RENESAS TECHNICAL UPDATE

Product Category	MPU/MCU		Document No.	TN-SY*-A0048A/E	Rev.	1.00
Title	Errata for User's Manual regarding the IIC		Information Category	Technical Notification		
Applicable Product	Renesas Synergy™ S5D5 MCU Group	Lot No.	Reference Document	S5D5 Microcontroller Group User's Manual Rev.1.30		
		All

The specified Renesas Synergy S5D5 User's Manual has incorrect statements about the IIC.

Page 1041 of 1734

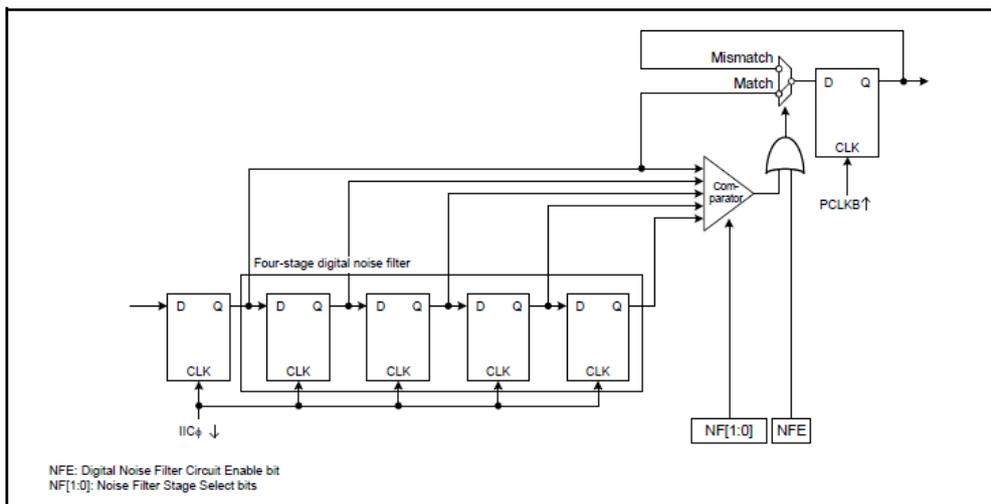
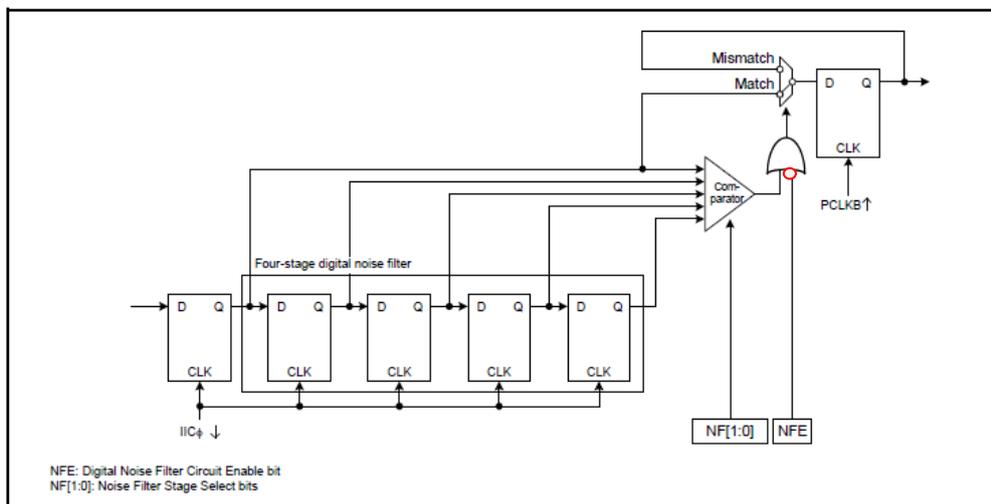
Incorrect

The IIC can also set the flag to indicate the detection of arbitration loss during NACK transmission in master mode or during data transmission in slave mode.

Incorrect Figure

Correct

The IIC can also set the flag to indicate the detection of arbitration loss during NACK transmission ~~in master mode~~ or during data transmission ~~in slave mode~~.

Correct Figure

Incorrect Figure

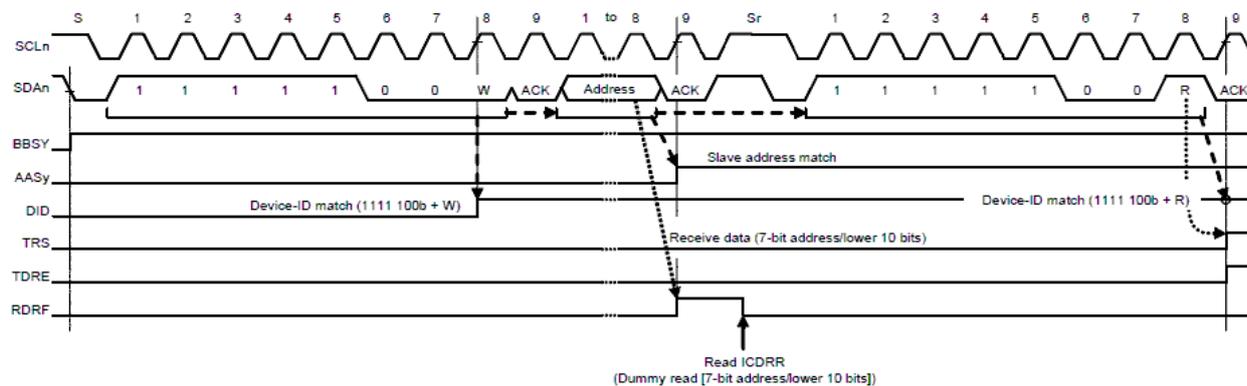
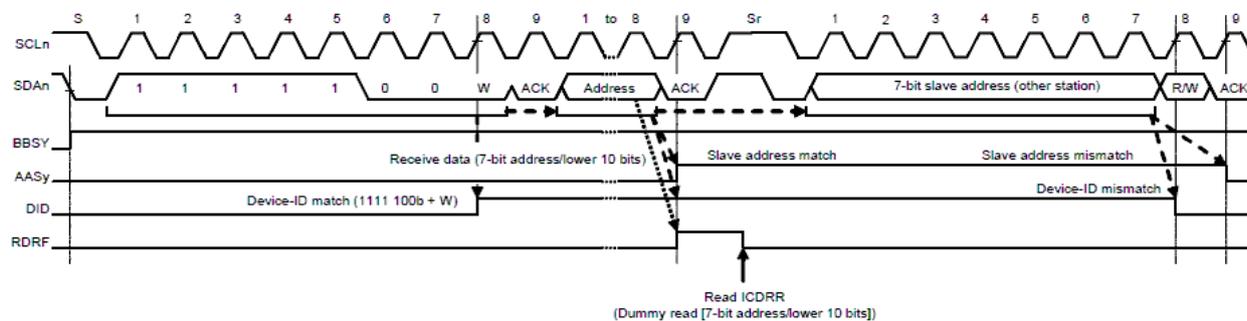
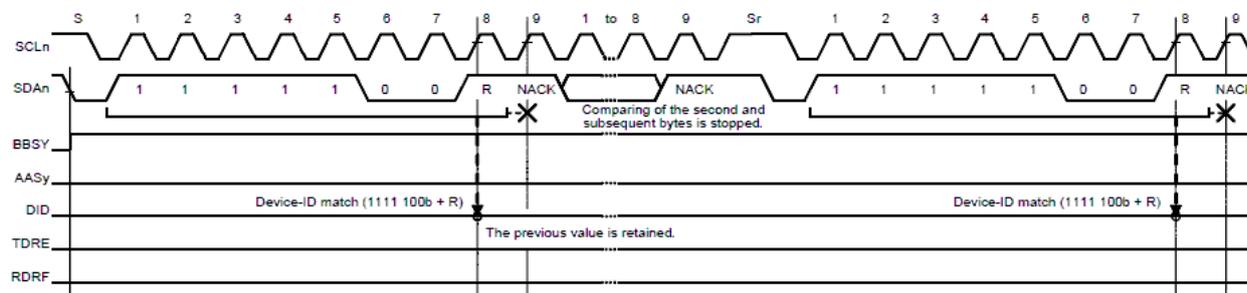
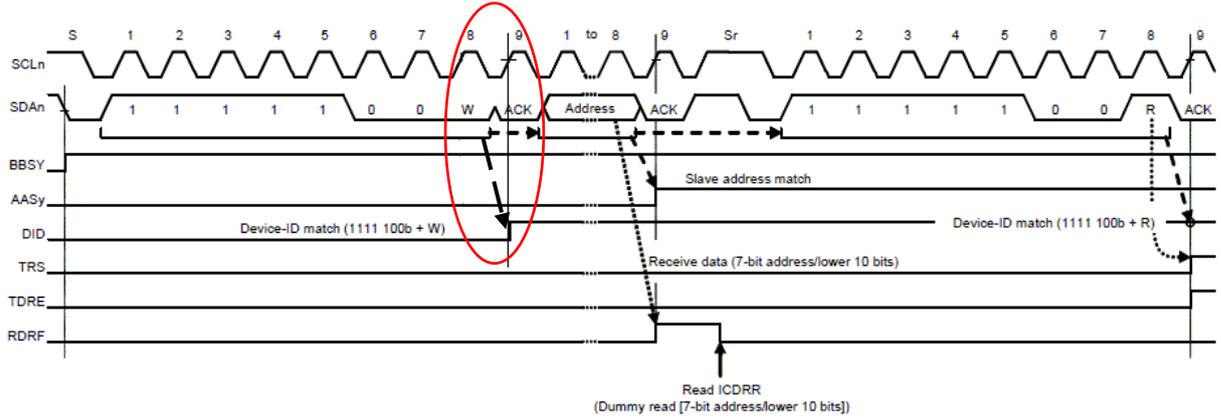
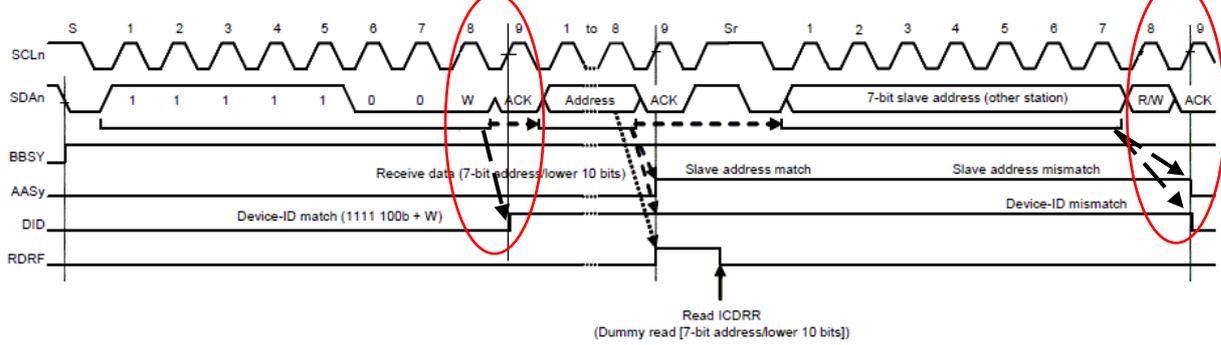
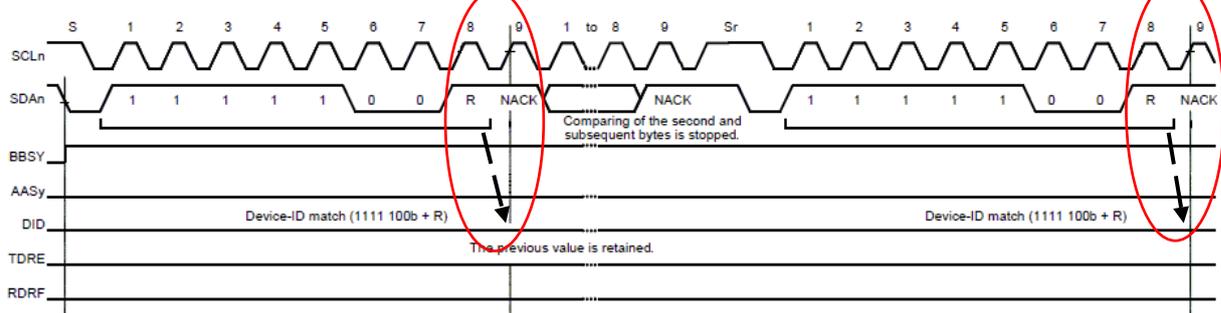
Incorrect

The IIC module provides detection of the device ID address in compliance with the I2C bus specification, revision 03. When IIC receives 1111 100b as the first byte after a start or restart condition is issued with the DIDE bit in ICSER set to 1, it recognizes the address as a device ID, sets the DID flag in ICSR1 to 1 on the rising edge of the 8th SCL clock cycle when the subsequent R/W# bit is 0, and then compares the second and subsequent bytes with its own slave address.

Device-ID reception

When address received after a restart condition is detected does not match the device-ID

When address before the device-ID + R does not match the slave address

Correct

The IIC module provides detection of the device ID address in compliance with the I2C bus specification, revision 03. When IIC receives 1111 100b as the first byte after a start or restart condition is issued with the DIDE bit in ICSER set to 1, it recognizes the address as a device ID, sets the DID flag in ICSR1 to 1 on the rising edge of the 9th SCL clock cycle when the subsequent R/W# bit is 0, and then compares the second and subsequent bytes with its own slave address.

Correct Figure

Device-ID reception

When address received after a restart condition is detected does not match the device-ID

When address before the device-ID + R does not match the slave address

Page 1082 of 1734

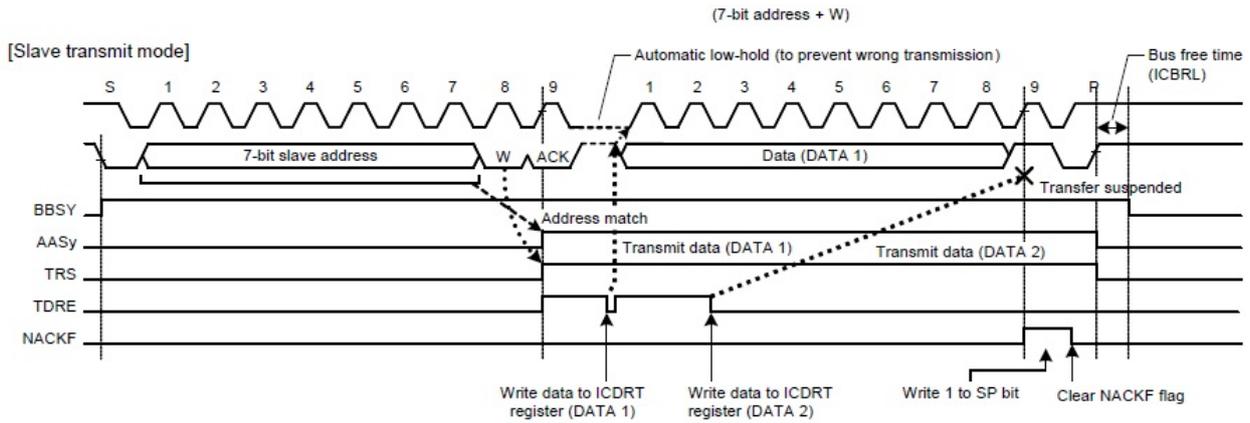
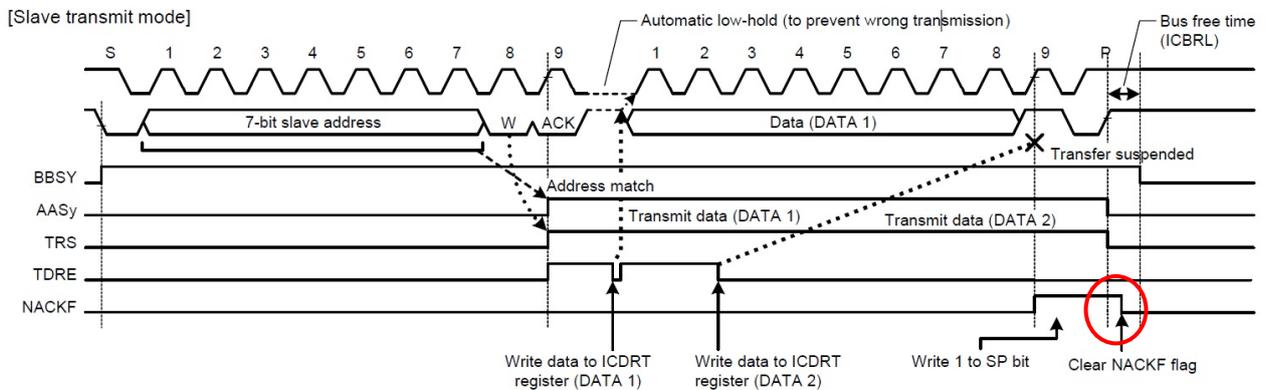
Incorrect Figure

Correct Figure

Page 1091 of 1734

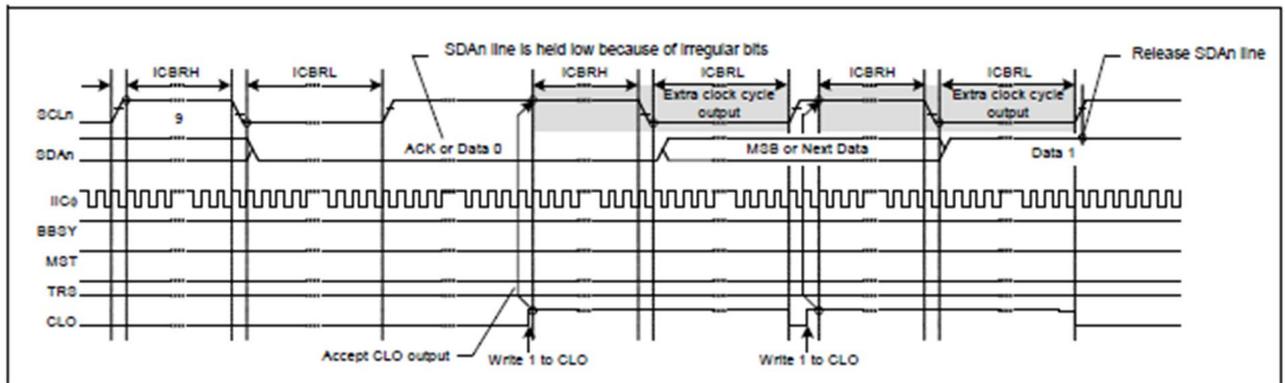
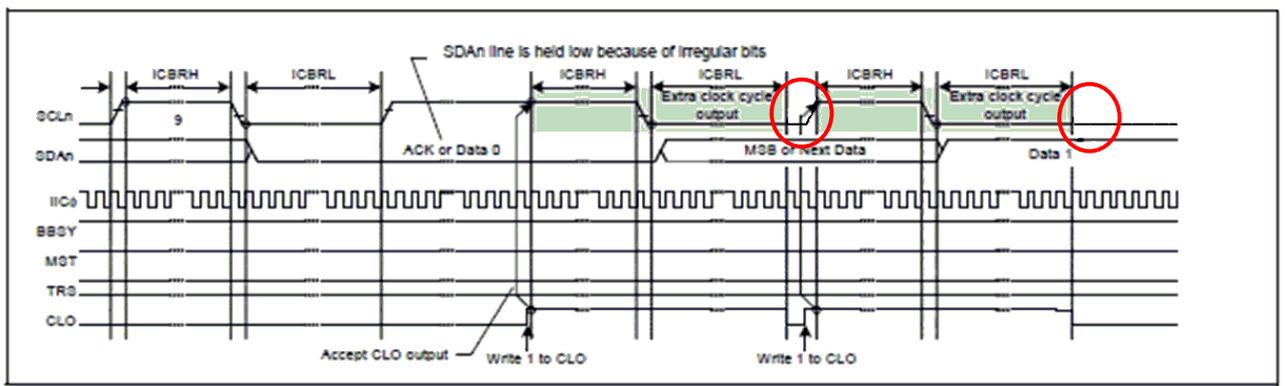
Incorrect

Use this function with the MALE bit in ICFER set to 0 (master arbitration-lost detection disabled). If the MALE bit is set to 1 (enabled), arbitration is lost when the value of the SDAO bit in ICCR1 does not match the state of the SDAn line.

Incorrect Figure

Correct

Use this function with the MALE bit in ICFER set to 0 (master arbitration-lost detection disabled). If the MALE bit is set to 1 (enabled), arbitration is lost when the value of the SDAO bit in ICCR1 does not match the state of the SDAn line.

Correct Figure
